Re: Pima Medical Institute New Class Room Building
4400 Cutler Ave. NE
Traffic Circulation Layout
Architect's Stamp 4-28-22 (H17-D054B)

Pima Medical Institute New Classroom – Traffic Circulation Layout 4400 Cutler Ave. N.E.

Responses to TCL Review Comments, Revision 4

TCL001

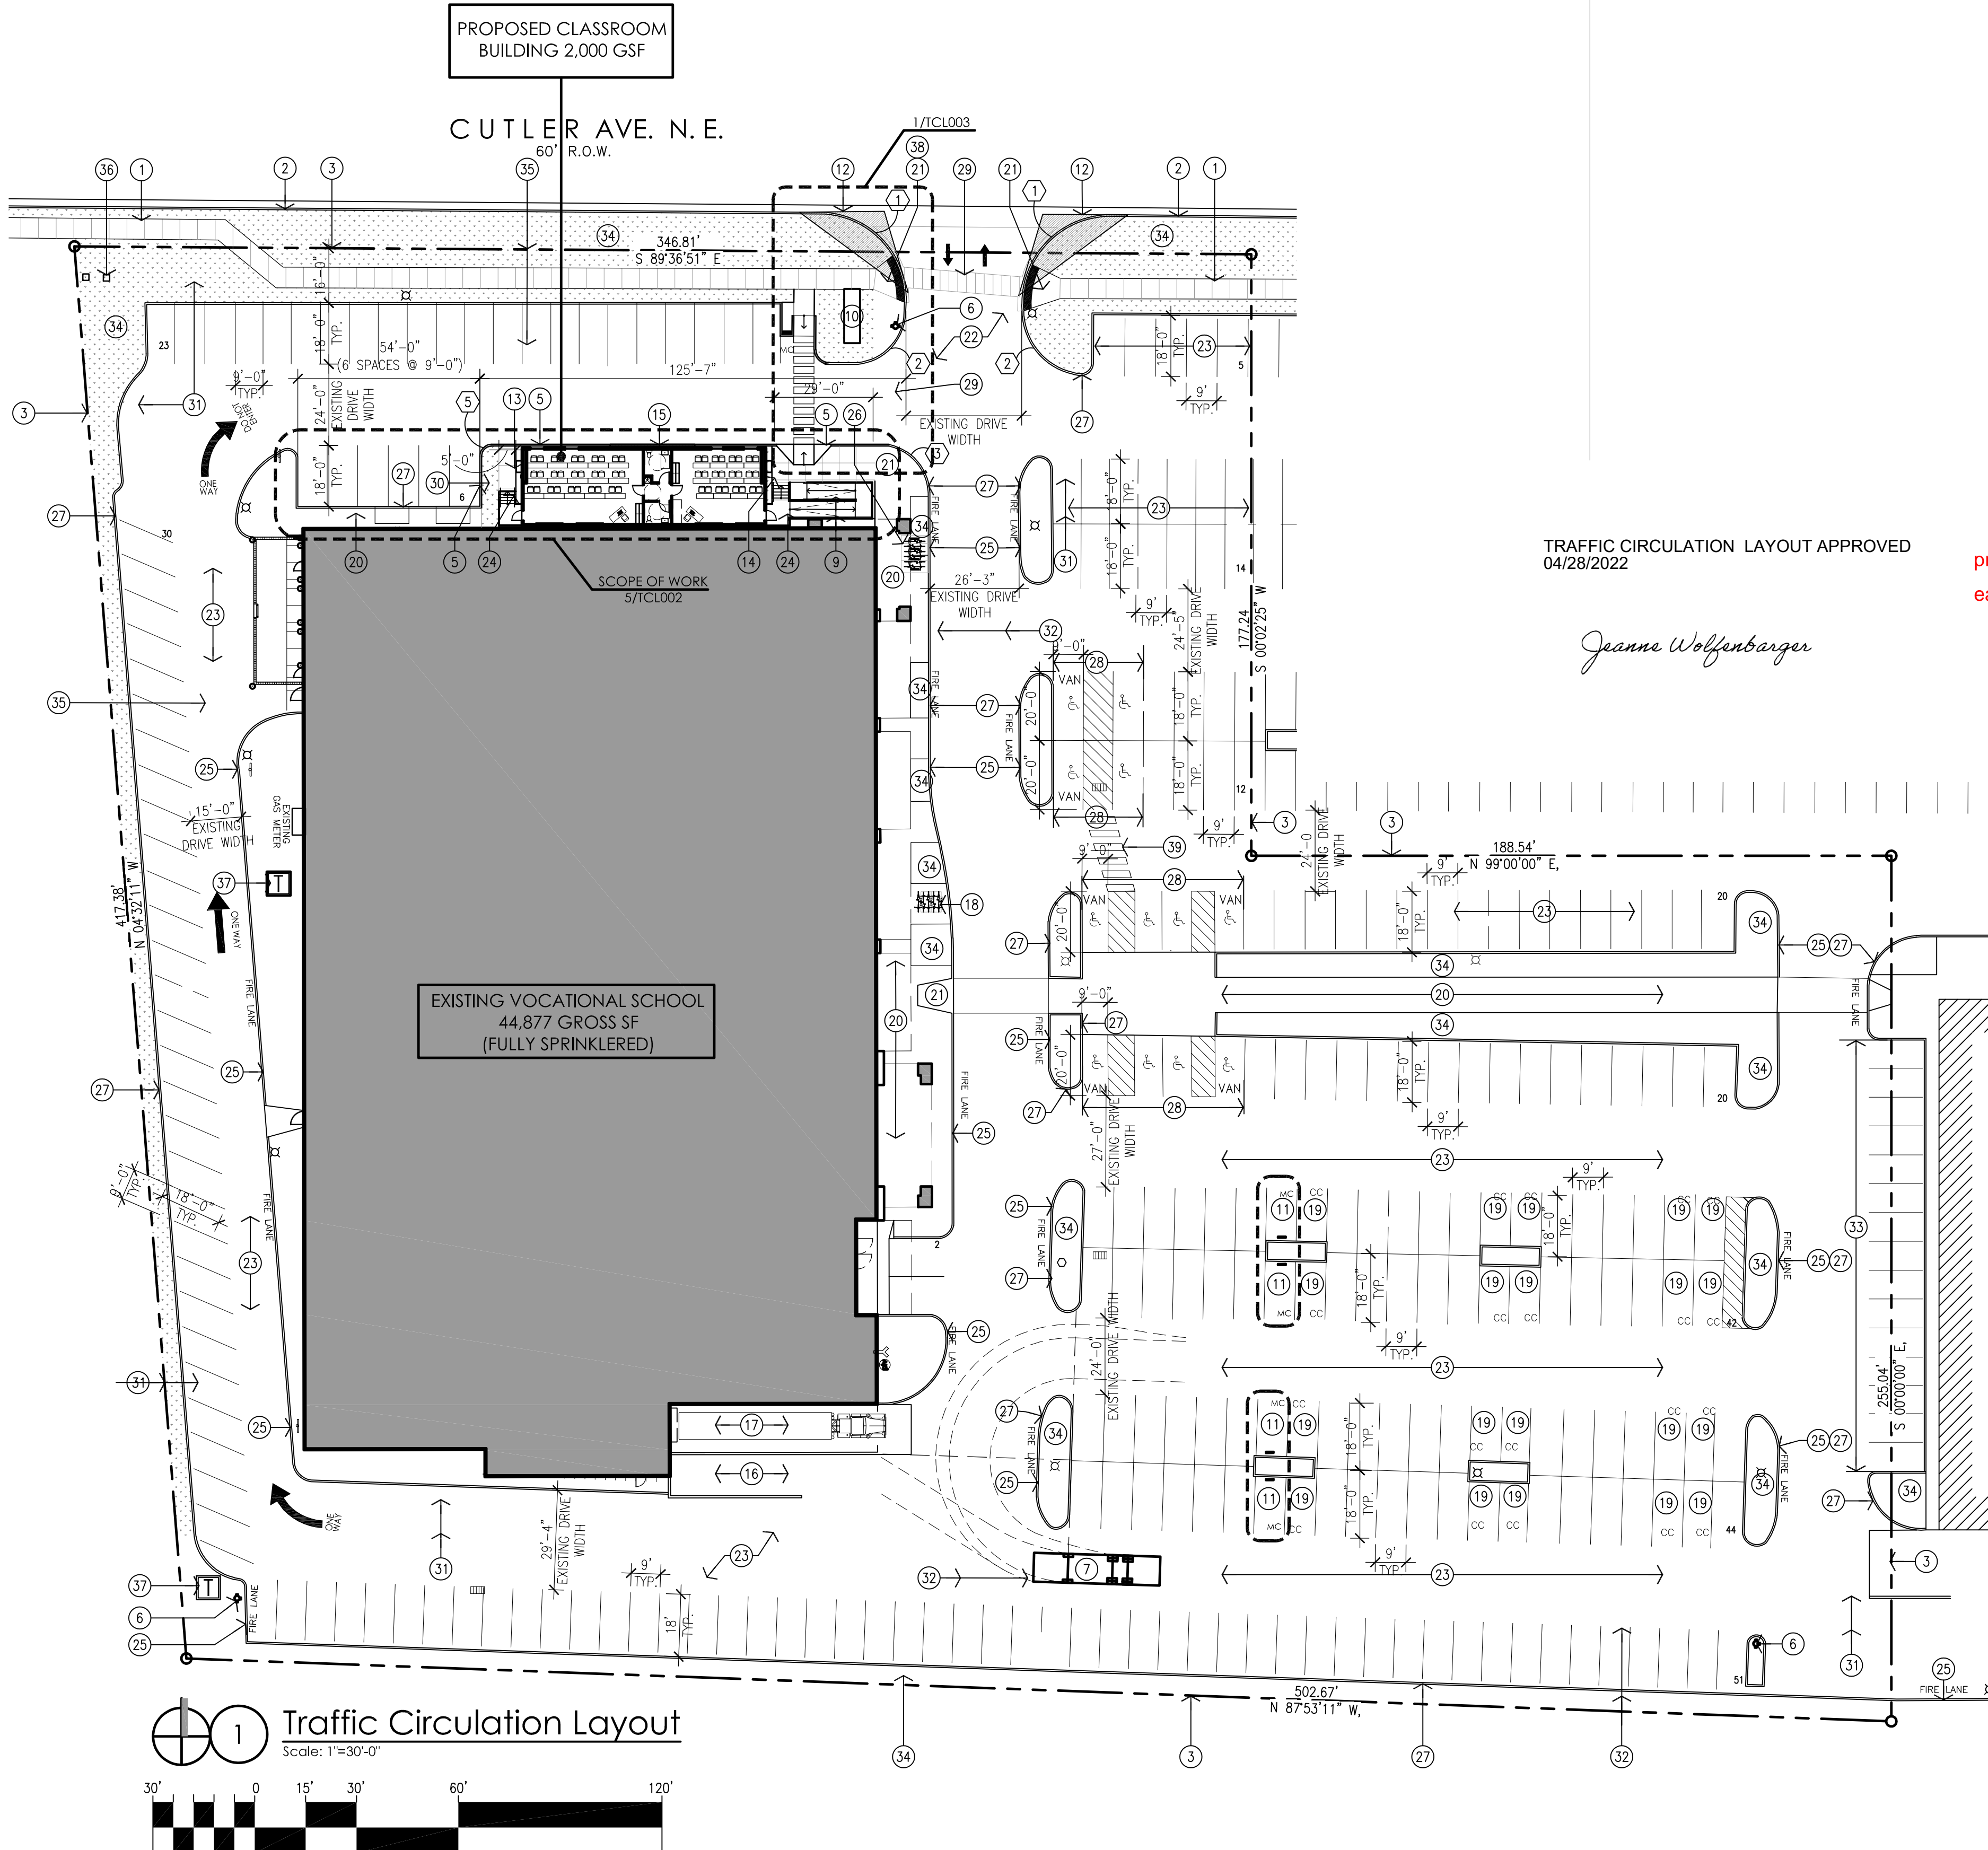
prior to Certificate of Occupancy, please have the city sidewalk easement in place as requested by Mr. Salgado.

2 H.C. Ramp Detail
Scale: Not To Scale (Isometric) FOR INFORMATION ONLY

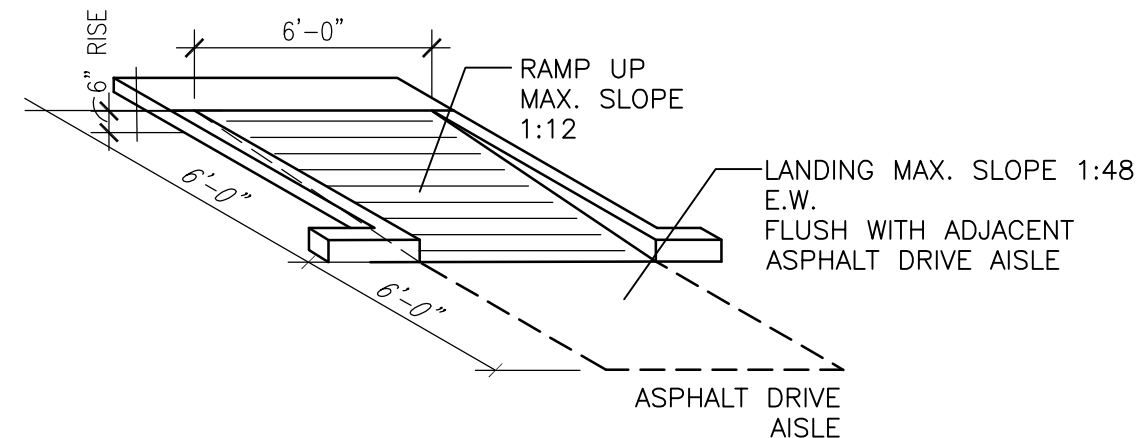
- Dimension all pathways widths on the proposed run/tapers and landings (including bottom, middle, top). Label all landings 48:1 MAX and all runs/tapers 12:1 MAX.

RESPONSE: Refer to Enlarged Ramp Plan, 5/TLC002, and Ramp Section, 7/TLC002, dimensions have been added to clarify the clear width of the ramp (between

handrails) is 5'-0". The notation 'max' has been added to the slopes on the ramps and landings.

SHEET
TCL003

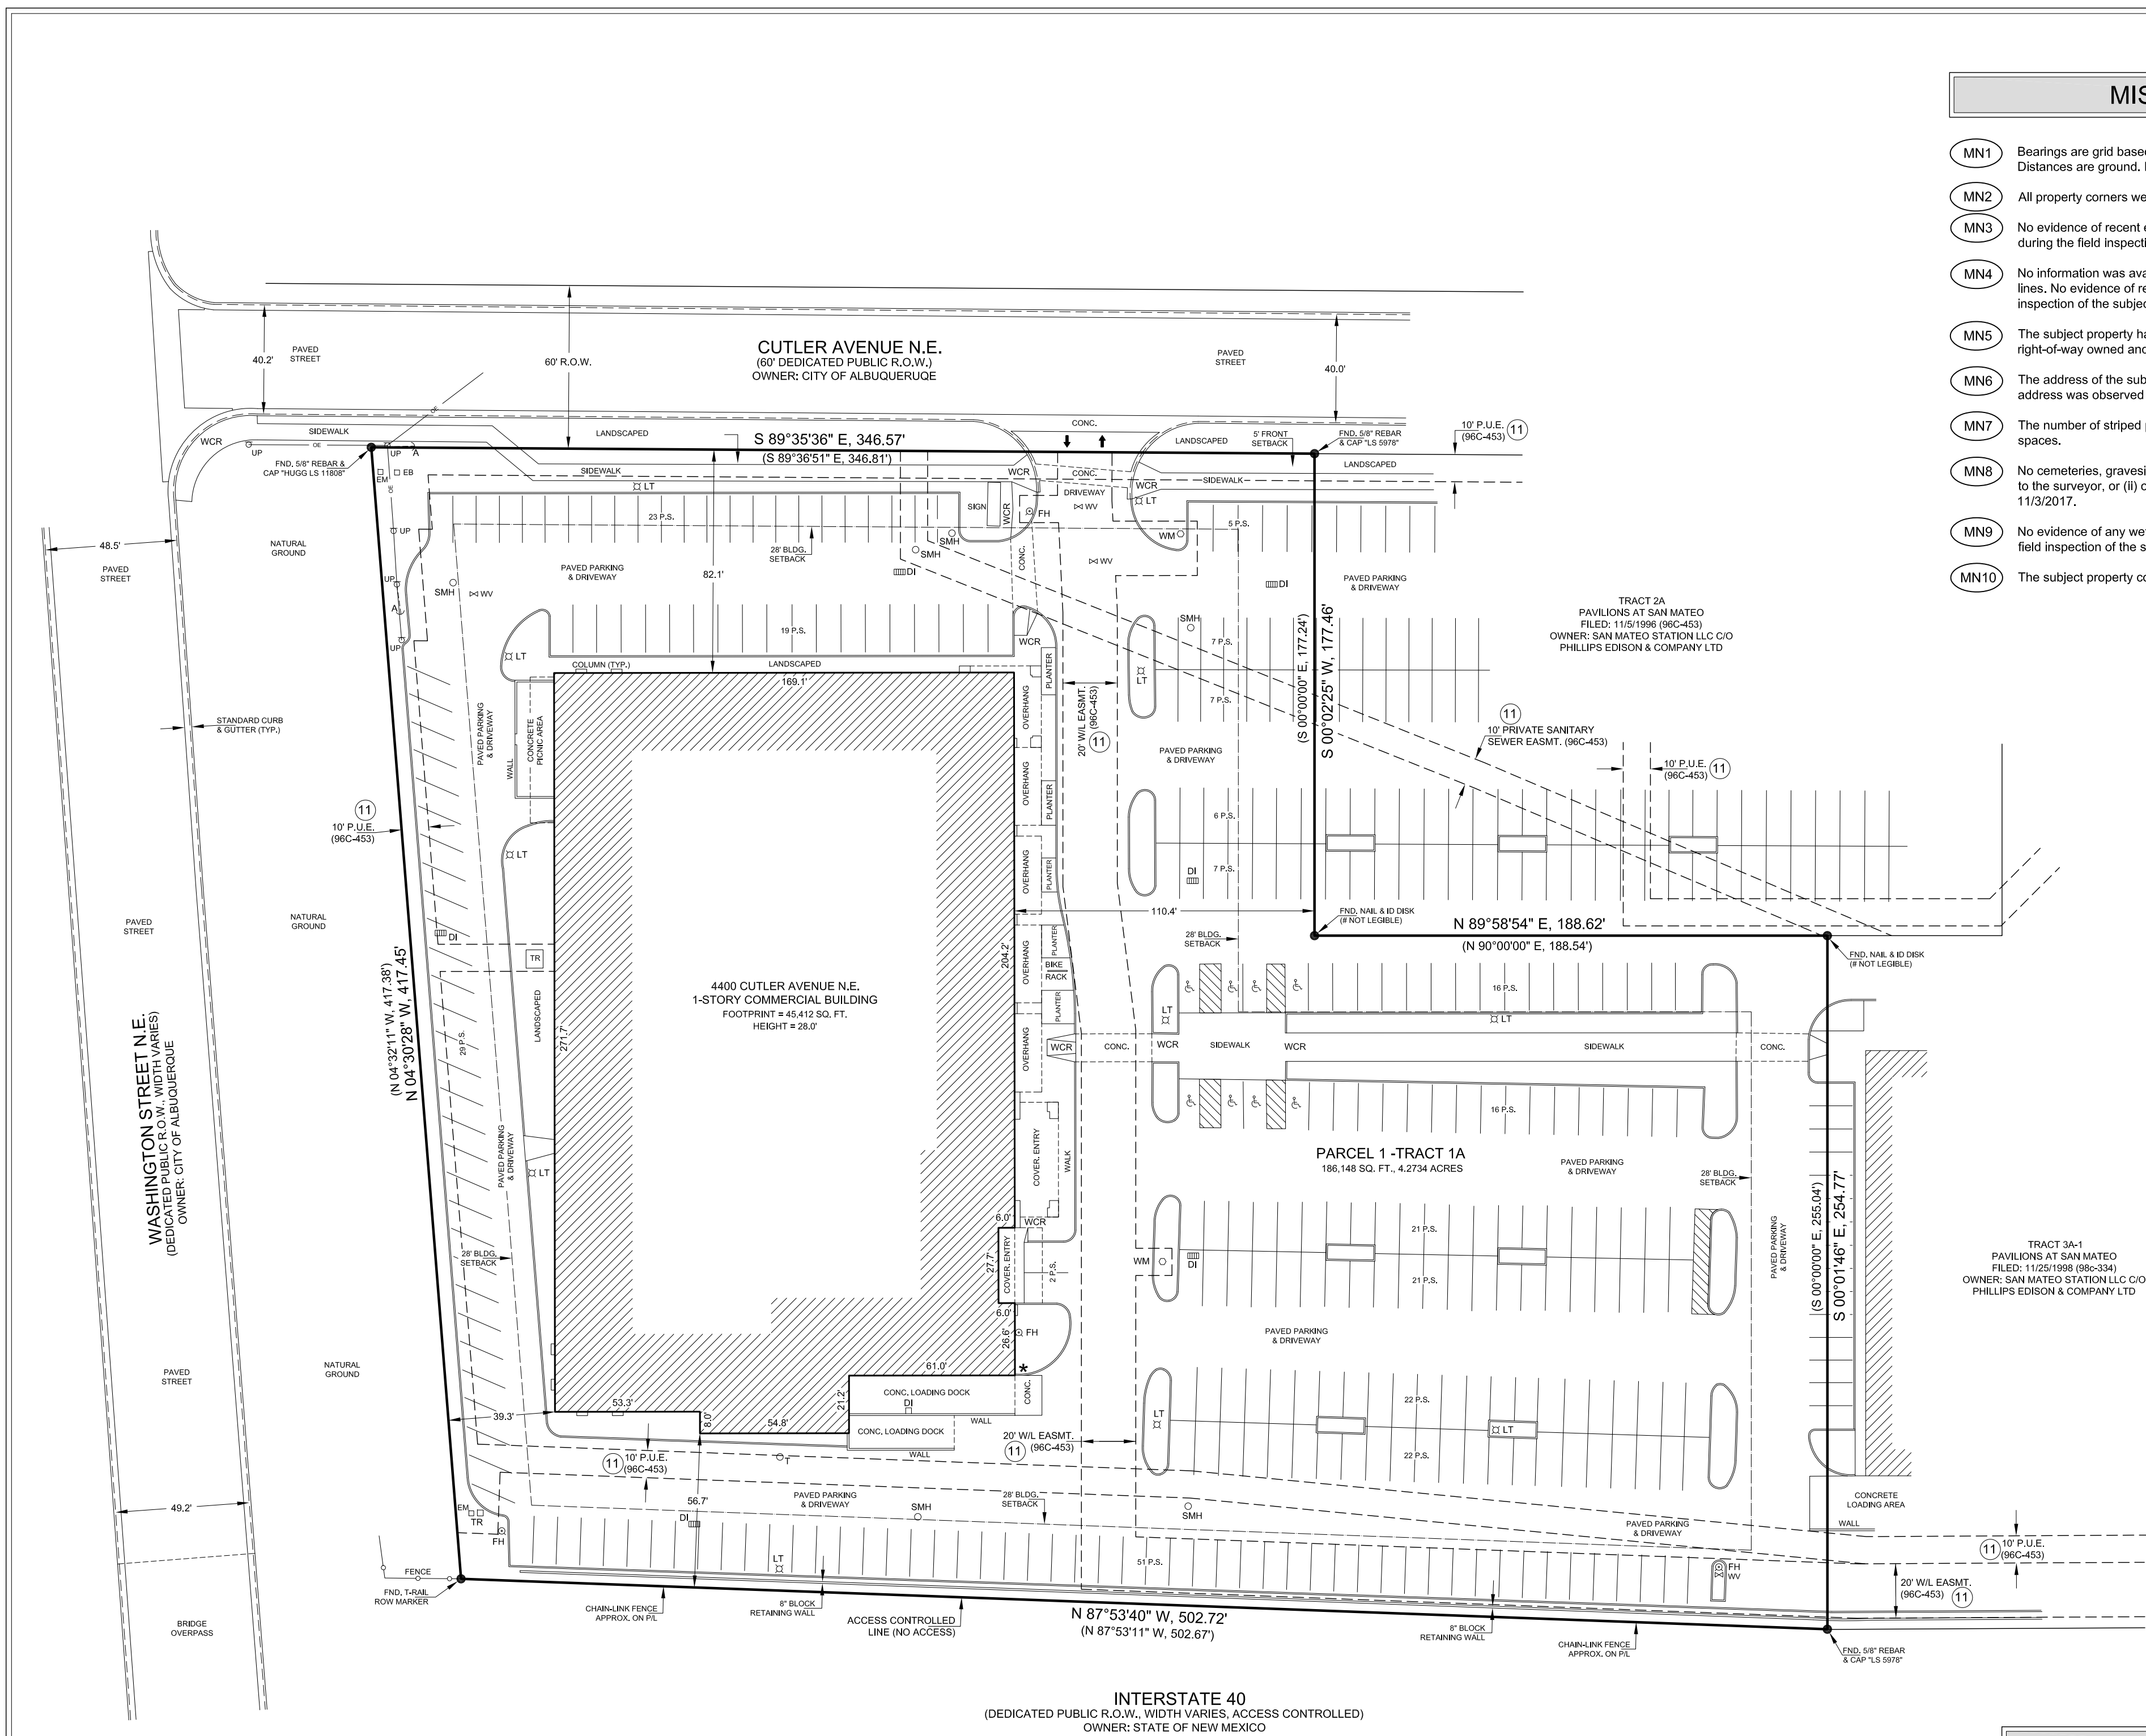
- The current ramp run (12:10) connection onto the sidewalk connection is not ADA accessible.

- Per DPM, a 6ft. wide ADA accessible pedestrian pathway is required from the public sidewalk to the building entrances Please clearly show this pathway and provide details and demo any existing/old sidewalk connections that doesn't meet the requirements above. Make sure you provide striping for this 6 ft. pathway across the drive aisle.

RESPONSE: Based on a conversation with Mr. Salgado-Fernandez, the existing curb ramp facing south on the west side of the curb cut off of Cutler Ave is not accessible. Even though this ramp is existing and has been in place since the shopping center was constructed, we propose to remove it and construct a new unidirectional ramp and pedestrian connection from the public sidewalk to the building. Please refer to Enlarged Site Plan 1/TLC003.

RESPONSE: Enlarged Site Plan 1/TCL2022 provides all the relevant notes to demo the non-accessible ramps and construct a new accessible path from the public sidewalk to the building entrance.
